AGENDA
REGULAR MEETING OF THE BIRMINGHAM PLANNING BOARD
WEDNESDAY SEPTEMBER 28, 2022 – 7:30 PM
151 MARTIN ST., CITY COMMISSION ROOM 205, BIRMINGHAM MI*

SUBJECT: 295 Elm St. – Forest Townhomes – Final Site Plan & Design Review

RE: Final Site Plan Review Comments
469-479 S. Old Woodward, Revised Site Plan

LANDSCAPE PLAN

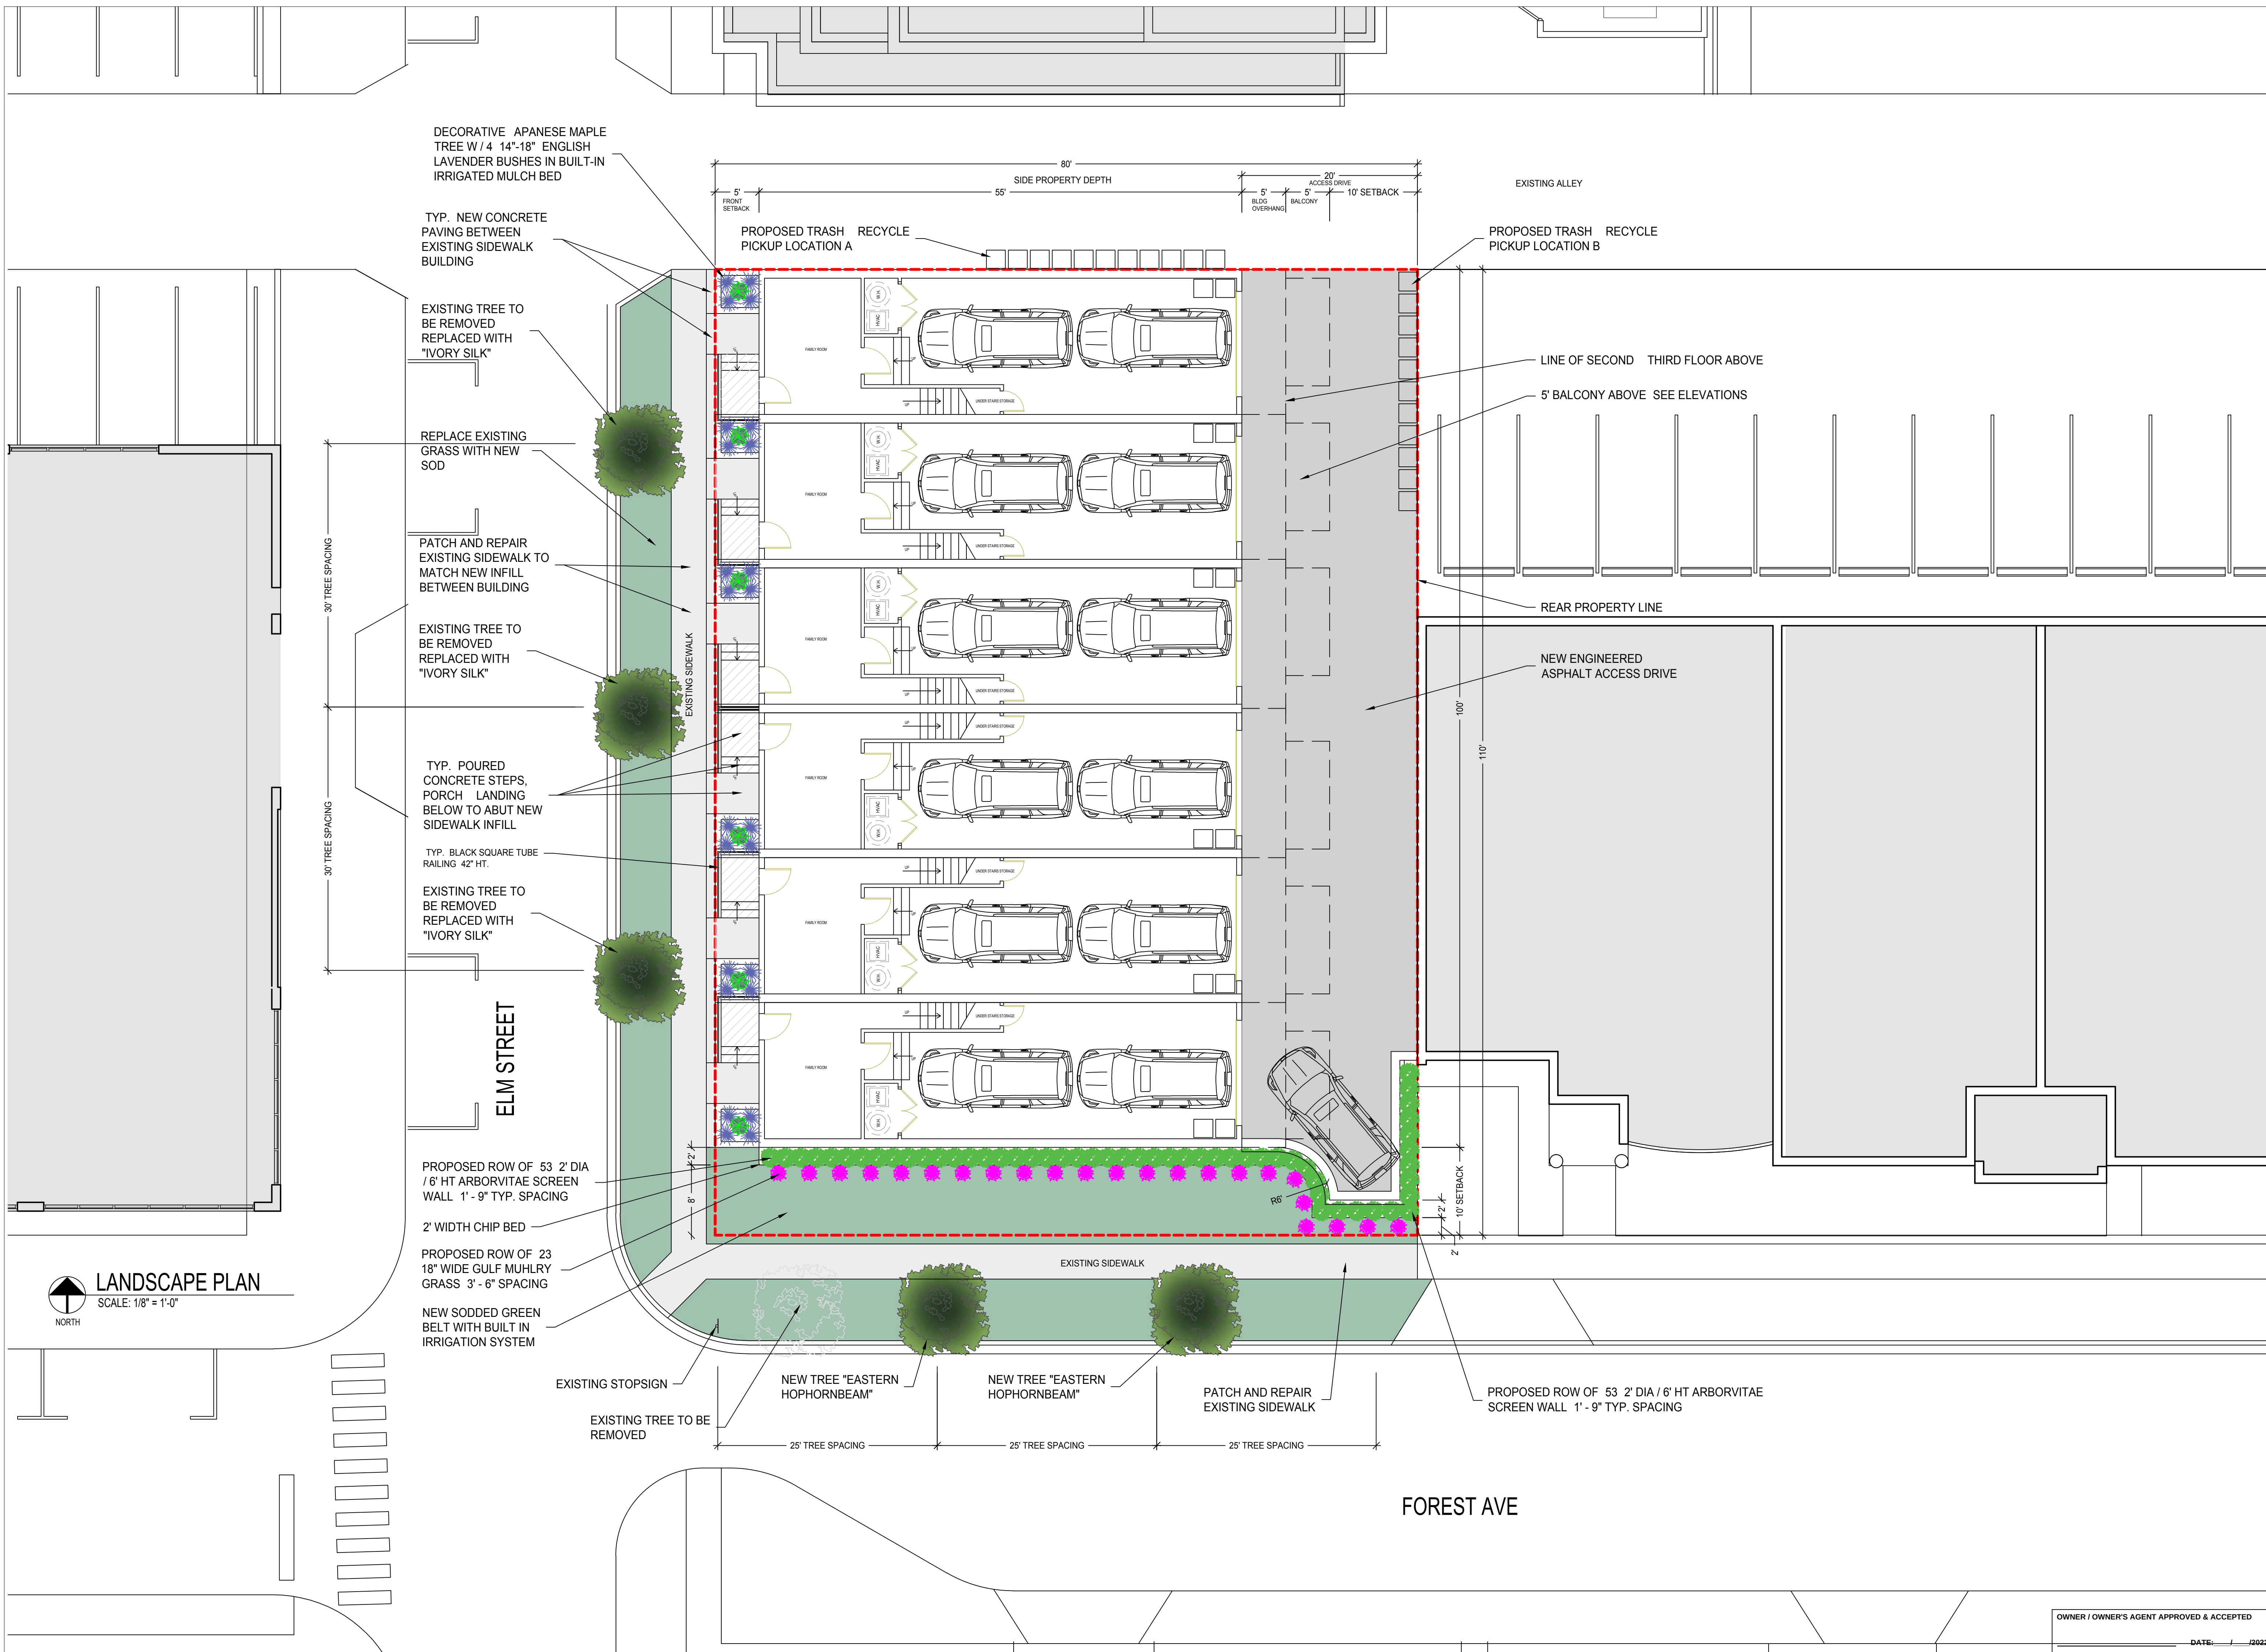
- 4.4 Landscaping – The applicant has submitted a landscape plan for the site which includes 6 planter boxes, one adjacent to each unit entrance containing a decorative ornamental tree and English Lavender bushes. Additionally, the applicant proposing a row of mature Hetz-Midget arborvitae along the south side of the property.

Although landscaping is not required in the ASF3/O1 zones, multiple family development such as this in other zones typically require deciduous and evergreen tree plantings. Due to the multiple-family development proposal and the sensitive location in between commercial and single-family zones, the applicant has included a row of 6’ tall arborvitae along the South façade of the building as well as a row of Gulf Muhly grass.

ROOF PLAN

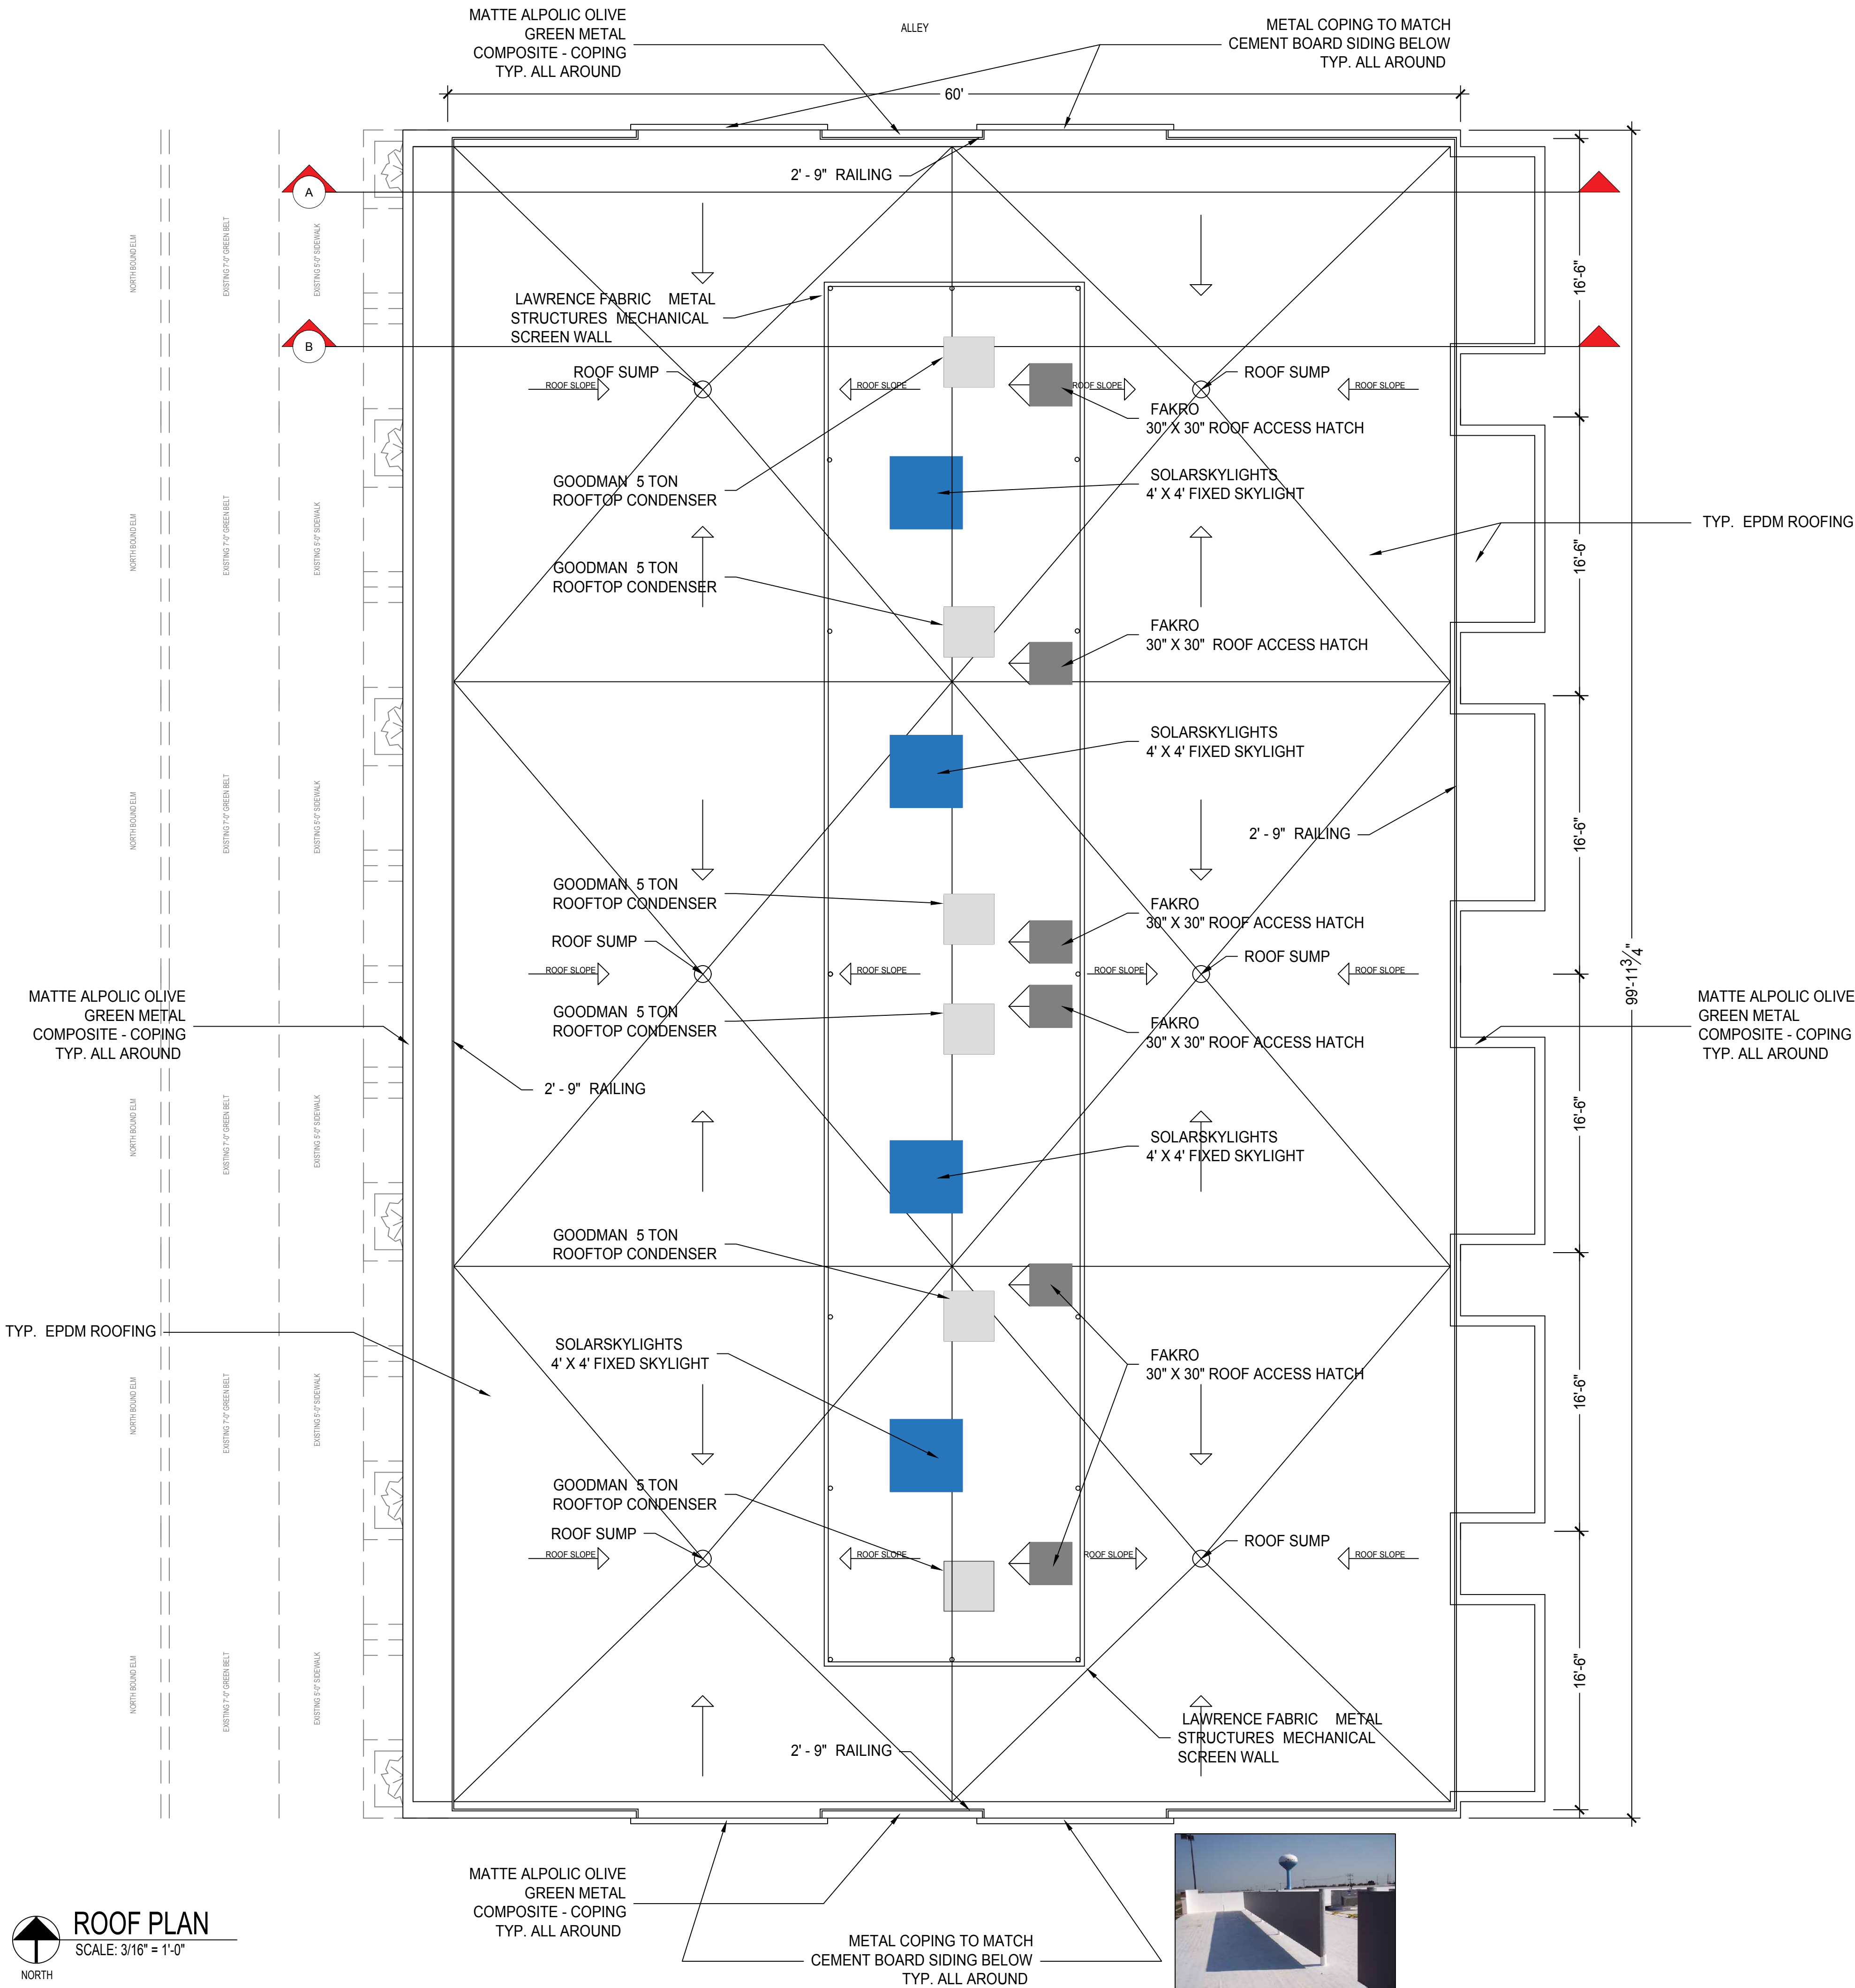
- 4.3 Mechanical Equipment Screening – The site plans proposed show a number of rooftop units proposed to be placed centrally on the rooftop above each unit. Based on the rooftop plan submitted, the applicant is proposing 3 ¼ ft. screen walls at all four sides of the rooftop. Article 4, Section 4.54(C)(8)(b) states that “to minimize the visual impact of such equipment from other points of observation, rooftop mechanical and other equipment shall be obscured by a screen wall composed of materials compatible with the building.” The proposed plans appear to meet the ordinance.
